Access Compliance Report

Public Rights-of-Way

(Curb Ramps)

Intersection ID: 10015635	Main Street: HARRIS_CORNERS_PY	Cross Street: N/A	Location: S
ADA ID: 6F18EBEB26CE	Ramp Type: PerpDiag	Initial Pass/Fail: Fail	Overall Compliance: No
Severity Score: 17.5			
Codes/Mitigation Info/Possible Solution		Field Measurements/Component Compliance

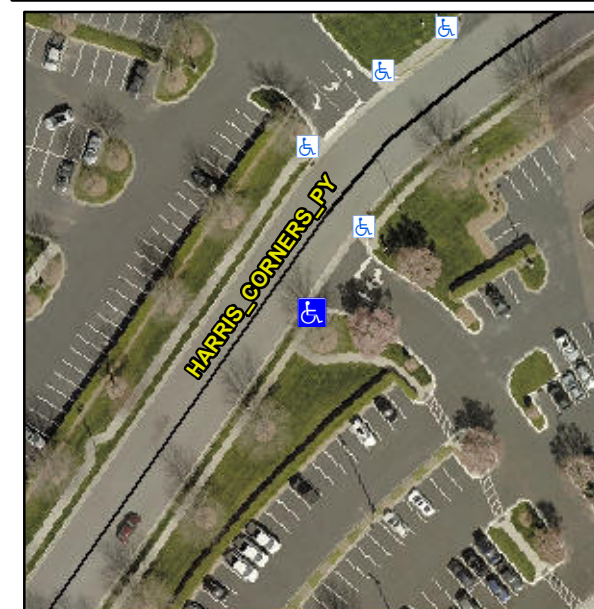
R304.5.1

Compliance	Description	Data	Compliance	Description	Data
N/A	Ramp Length (in)	69.0	Yes	Ramp Slope (%)	6.4
No	Ramp Width (in)	35.0	Yes	Ramp XSlope (%)	1.2
N/A	Flare Type LT	N/A	N/A	Flare Type RT	N/A
N/A	Flare Slope LT (%)	N/A	N/A	Flare Slope RT (%)	N/A
N/A	Flare Traversable LT?	N/A	N/A	Flare Traversable RT?	N/A
N/A	Landing Length (in)	N/A	N/A	DWS Provided?	N/A
N/A	Landing Width (in)	N/A	N/A	DWS Contrast?	N/A
N/A	Landing Slope (%)	N/A	N/A	DWS Length (in)	N/A
N/A	Landing X Slope (%)	N/A	N/A	DWS Full Width?	N/A
N/A	Landing Curb? (Y/N)	N/A	N/A	DWS Offset (in)	N/A
N/A	Shared Landing?	N/A			
N/A	Gutter Ponding?	N/A	N/A	Gutter Slope (%)	N/A
N/A	Gutter Lip Ht (in)	N/A	N/A	Gutter X Slope (%)	N/A
N/A	Painted X Walk1?	No	N/A	Painted X Walk2?	No
	X Walk 1 Direction	To NE		X Walk 2 Direction	To NW
N/A	X Walk 1 Width (in)	N/A	N/A	X Walk 2 Width (in)	N/A
	X Walk 1 Slope (%)	0.7		X Walk 2 Slope (%)	2.8
	X Walk 1 X Slope (%)	1.5		X Walk 2 X Slope (%)	1.7

Remove & Replace Curb Ramp With Two New Directional Ramps or Equivalent.
